APPLICATION NO.	FILING DATE	FIRST NAMED INVENTOR	ATTORNEY DOCKET NO.	CONFIRMATION NO.
09/665,899	09/20/2000	Masayoshi Iwase	10517/74	6300

# Office Action Summary

## DETAILED ACTION

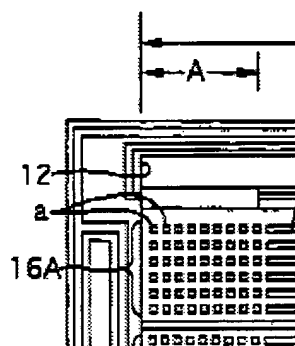
The rejection is maintained for the reasons of record for amended claims 1-18. The scope of the present claims, specifically independent claim 1, have been amended so as to recite "a gas

supply inlet which connects the fluid passage and supplies a gas to the fluid passage therethrough, wherein the gas supply inlet is located so that a gas flow between the gas supply inlet and the fluid passage is parallel to a gas flow in the fluid passage". In view thereof, Applicant submits that the claimed invention allows for gas "flowing from passage 305 directly onto surface 311 in the direction of flow across the joint body, *i.e.*, without having to immediately turn to begin flowing down the gas flow path". (Applicant's response, page 5) In reply, however, the examiner submits that the scope of the present claims does not preclude the gas supply inlet to result in the gas flow to "immediately turn" prior to flowing down the fluid passage. Further, the scope of the present claims does not recite *the extent* to which the gas flow between the inlet and the passage is parallel to flow of gas within the passage itself. [emphasis added] It appears to the examiner that Applicant intends to claim the substantially linear flow of gas between hole [305] and hole [306] such as illustrated in Figure 6, prior to the gas flow making a turn such as indicated by the arrows. However, absent of more clarifying language, in Kurita the gas flow between the inlet [12] and the passage is asserted parallel to the flow of gas within the passage itself such as at least within passage areas [16a], [17b] or [17d], since the scope of the present claims does not require the gas flow to traverse the entire length of the separator plate.

As to new independent claims 20 and 24, the rejection of record is similarly applied in addition to the following. The plurality of regions [16a], [17b], [17d] communicate with each other in that the regions are contiguous with respect to the gas flow passages formed therein. As to a regular pattern across the width of each region, it is asserted that a regular pattern of, e.g., six [a] projections or six [b] rib portions are present within each region. As to a regular pattern

across the length of each region, it is asserted that a regular pattern of nine [a] projections at both ends of each region with an intervening rib portion [b] disposed parallel to its length is present.

First turning passage:

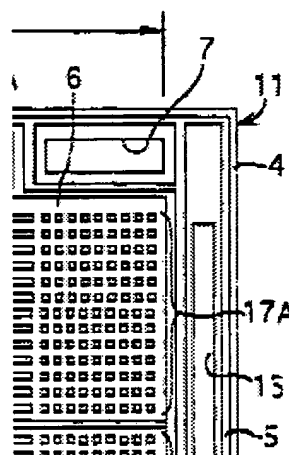
As to claims 22 and 26 which recite a width of a turning passage between the end of the rib portion and an opposing peripheral wall of the separator, to the extent that the claims are understood by the examiner for the reasons discussed under 35 U.S.C. 112, second paragraph (discussion above), the width of the starting end of the rib projection [16a] when measured from this rib portion end and an opposing peripheral wall is less than the width of the immediately upstream region. For clarification, enhanced portions of the turning passages are herein shown:

Second turning passage:
